PCN – Process Change Notification

Change:	OMB.868.B05F21
Date:	2017/02/23
Author	Bonnie Chen

Model#	Part Number	Changes
868MHz 5dBi Omni Antenna, with N Type Female Connector, U-Bolt, 818.75mm Length	OMB.868.B05F21	<ol style="list-style-type: none"> 1. Change Antenna Length 2. Amend Details on Drawing 3. Amend Package Rule

Old drawing

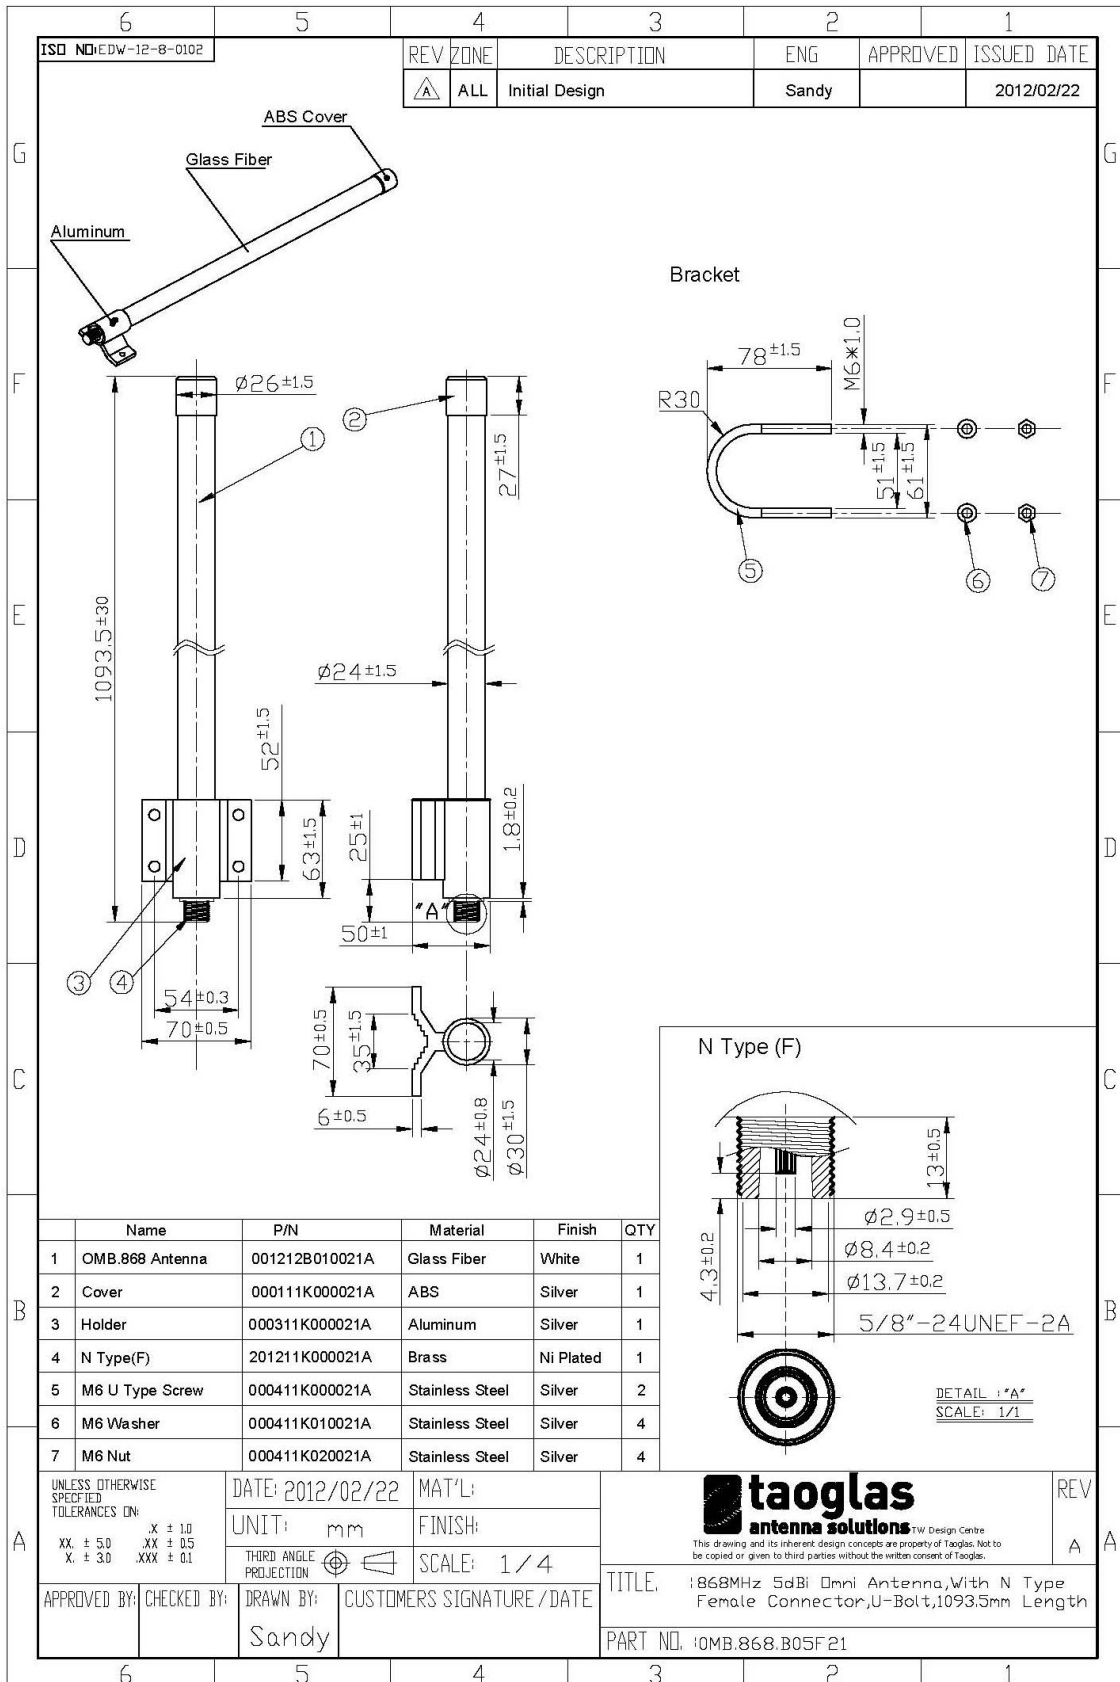
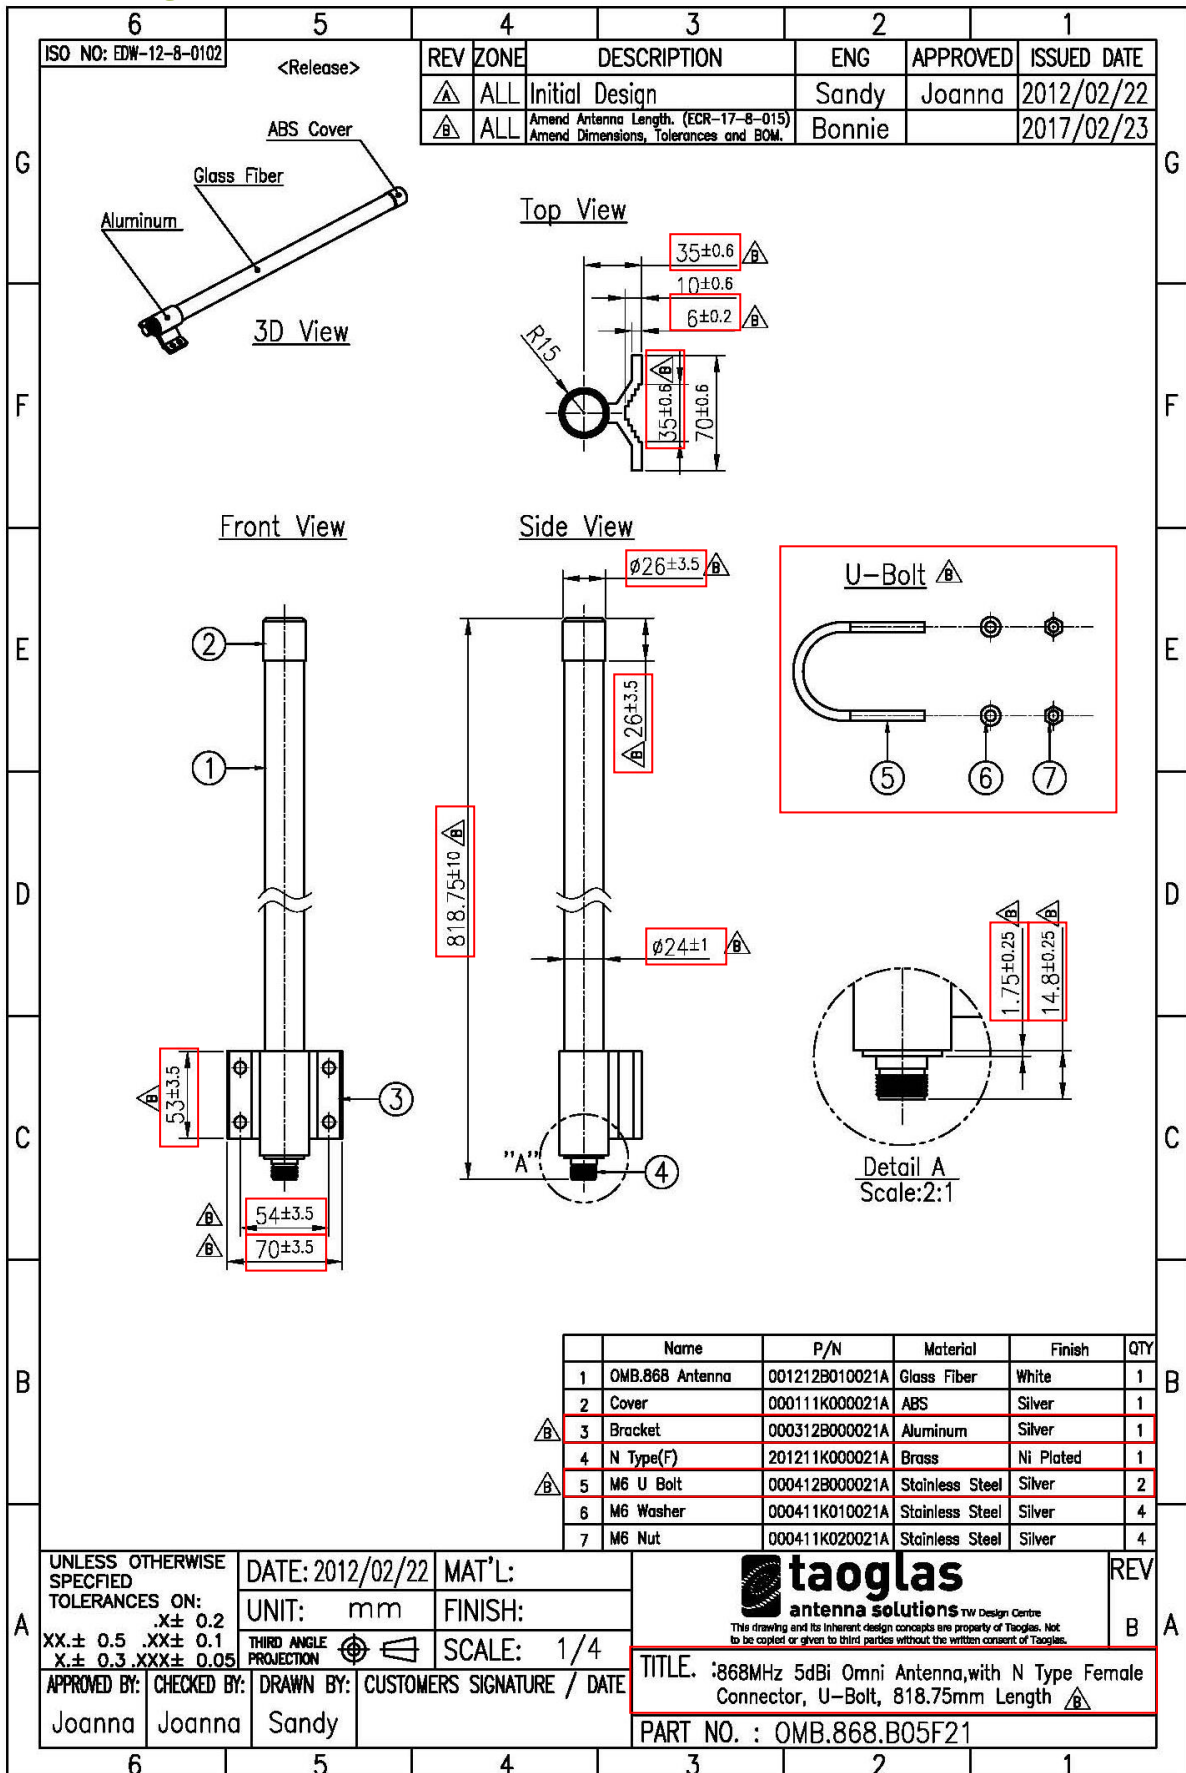
1. Amend Antenna Length from 1093.5+/-30mm to 818.75+/-10mm.
2. Amend Title, Dimensions, Tolerances and BOM on Drawing.
3. Amend Package Rule.
